**MAJOR PROJECT ASSESSMENT:  
Mixed Use Residential, Retail and  
Commercial Development  
330 Church Street, Parramatta  
(MP 10\_0171)**

Director-General's  
Environmental Assessment Report  
Section 75I of the  
*Environmental Planning and Assessment Act 1979*

October 2012

**Figure 5: Northern and Western Elevations**

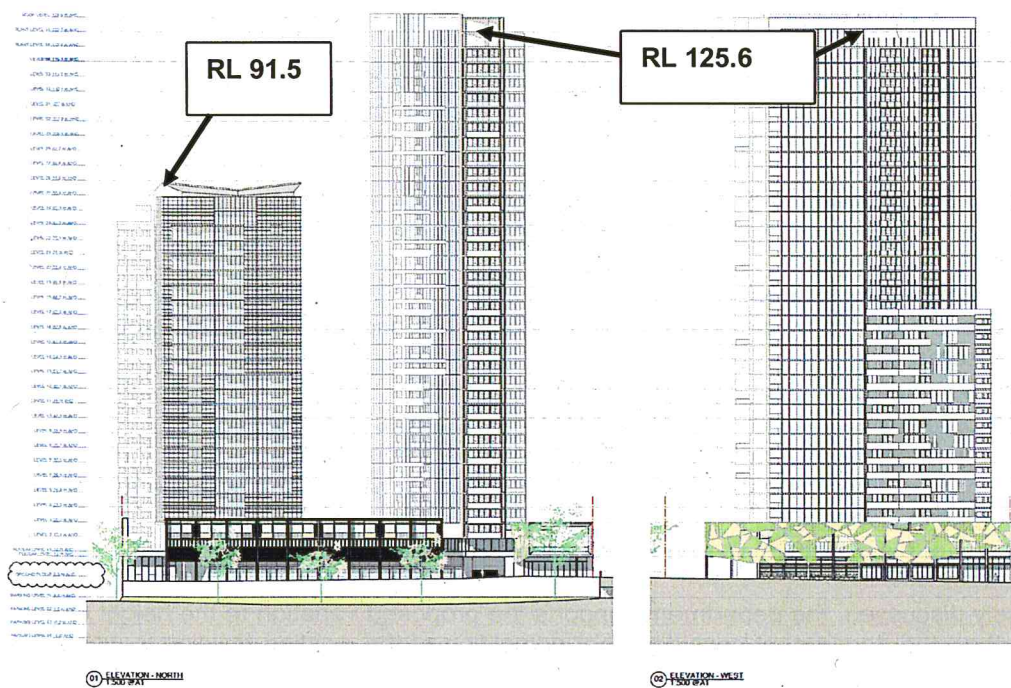
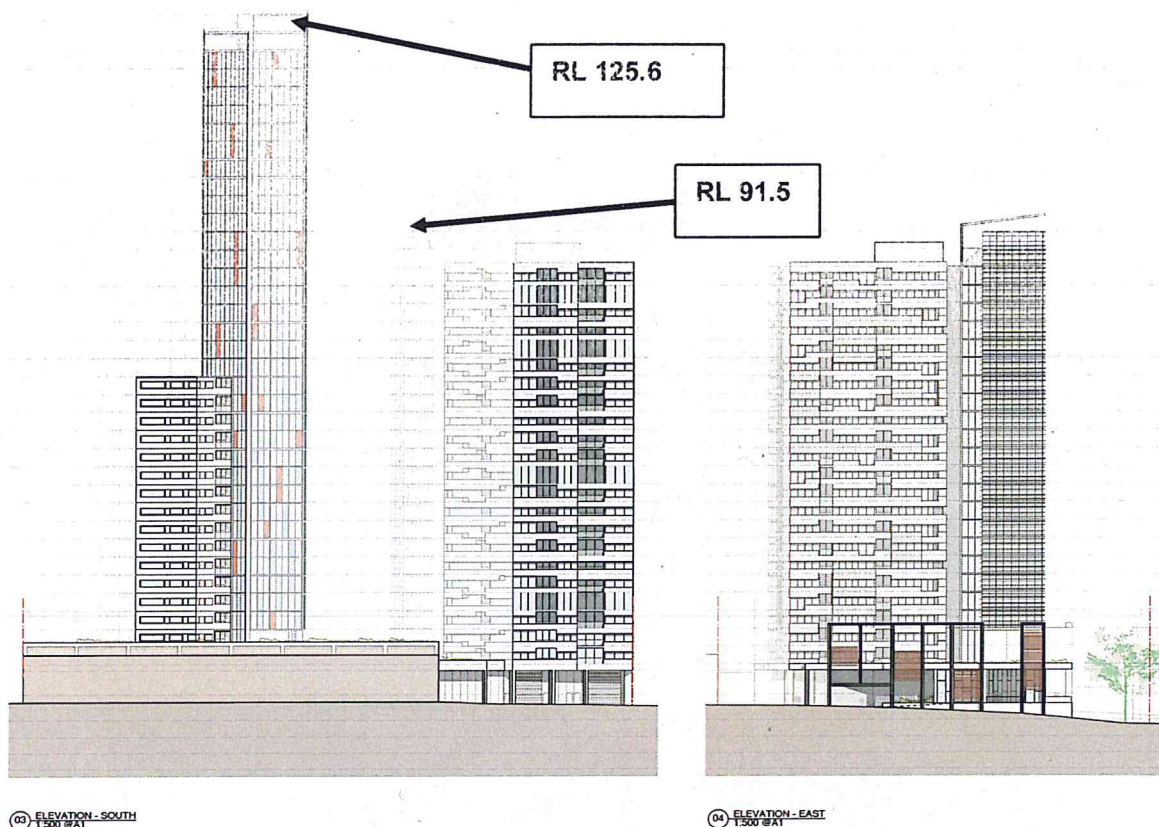
In this regard, the eastern tower requires a 5.3 per cent variation (11.5 m) to the height control and the western tower requires a 46.9 per cent variation (45.6 m). Furthermore, the project requires an 8.6 per cent variation to the maximum FSR permissible on the site. **Table 2** below provides a summary of compliance with the height and FSR controls applicable to the site.

**Figure 10:** Comparison of Compliant Building Envelopes<sup>1</sup> and the Non-Compliant Portion of the Building Project.

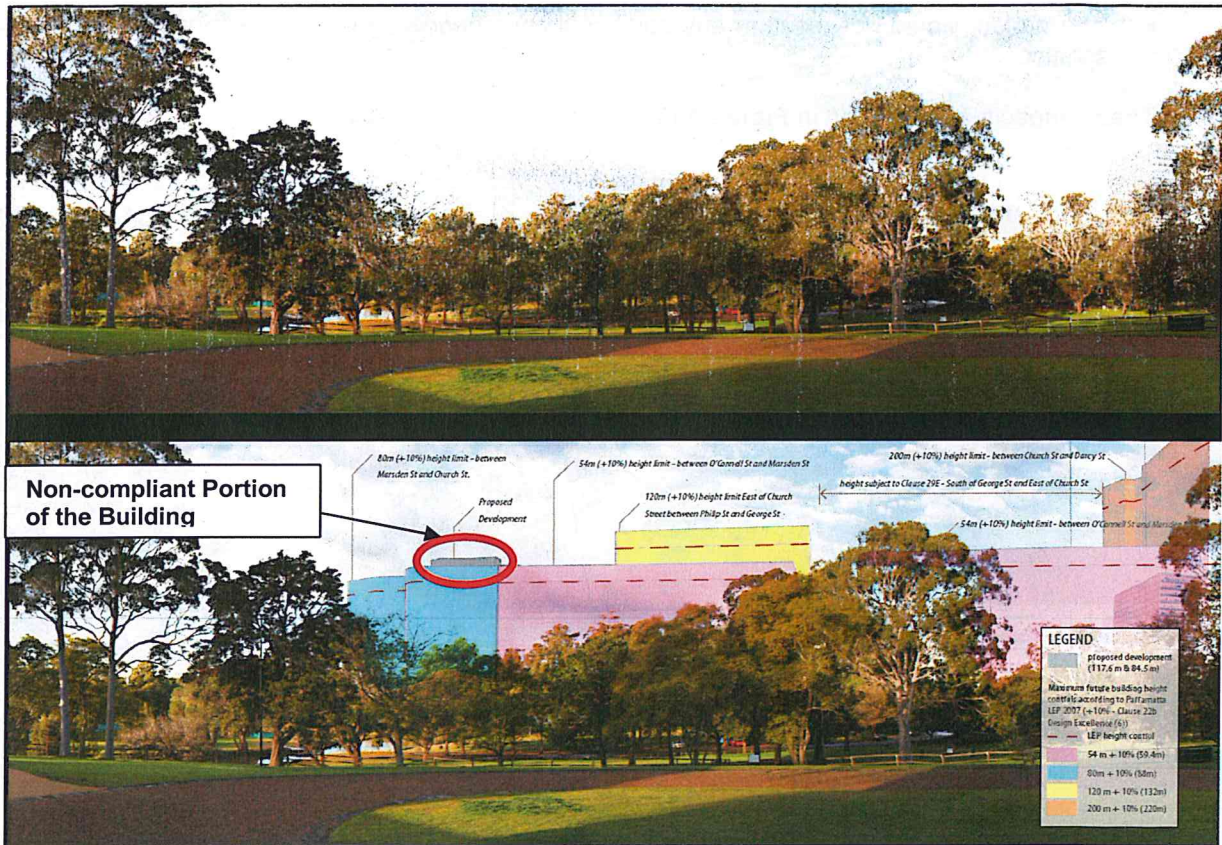
- Whilst the development would be visible from the front of Government House and within the grounds of The Domain, it would not have an overbearing impact given that it is setback a significant distance (500 m) from the eastern boundary of the Domain (see **Figure 9**).
- As the PCC LEP permits developments of up to 80 m in height on the block immediately east of the site fronting Marsden Street, the non-compliant portion of the building would not be discernable once this street block is redeveloped (see **Figure 10**).

**Figure 14: Extent of Existing Flood Prone Land**

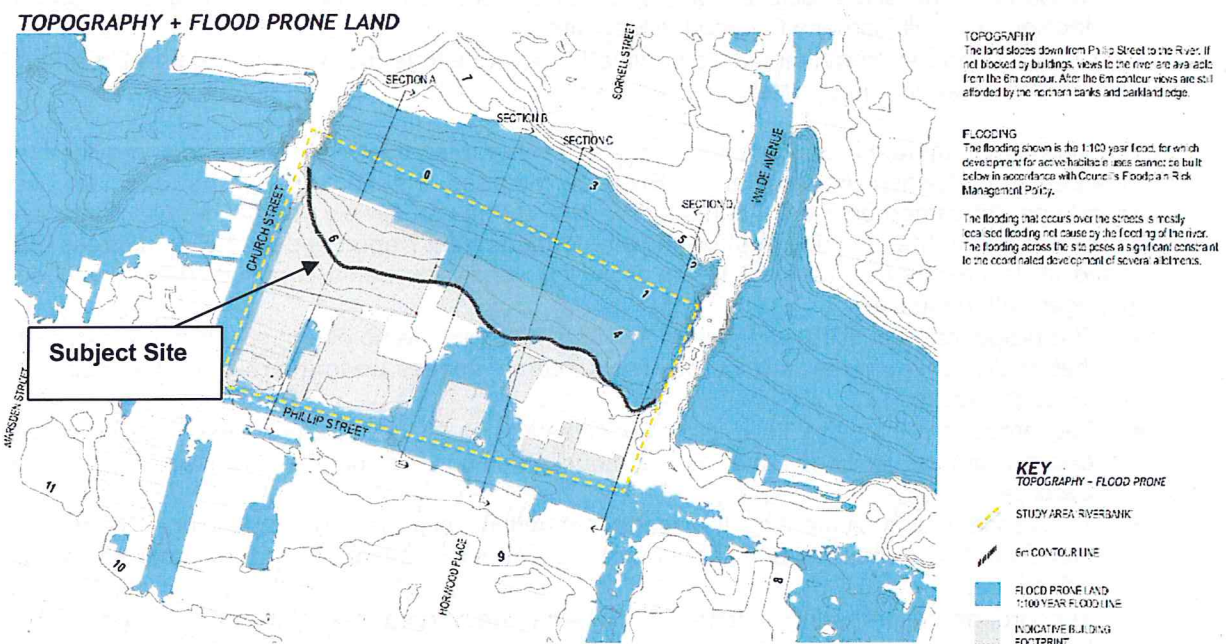
- The flood planning levels have been applied inconsistently across the site.
- The car park ramp level at the basement car park entrance is set too low and should be increased to 7.48 m. Evidence should also be provided that increasing the car park ramp level will not affect compliance with the relevant Australian Standards.
- The proponent should certify that there will be no openings within the building below the flood planning levels.
- The flood risk analysis is insufficient, and an assessment of the flood risk for all PMF levels surrounding the site should be provided. In addition, the analysis should quantify whether the development will increase the flood risk on site.
- An evacuation strategy should be provided to demonstrate that the any risks to life and property can be managed appropriately.

The proponent updated its Flooding and Stormwater Management Report and provided a Flood Emergency Response Assessment (FERA) to address the findings of the peer review. The department forwarded both documents to Evans and Peck for review. In this regard, Evans and Peck advised that both the Flooding and Stormwater Management Report and the FERA address the issues raised in its peer review, subject to the following conditions being imposed to ensure flood risk is managed within the site:

- The proponent providing evidence to the Certifier there are no openings within the external façade that could convey water into the building's internal spaces up to the relevant flood planning level for each façade.
- The proponent installing flood proofing measures to all building entrances that sit between the external ground level and the internal flood planning level prior to the issue of an Occupation Certificate.
- The proponent implementing the recommendations provided within Section 7 of the FERA, in particular the provision of a stair connection between the basement, ground floor and the first floor refuge area.
- The proponent preparing a formal flood emergency response plan prior to occupation of the building.
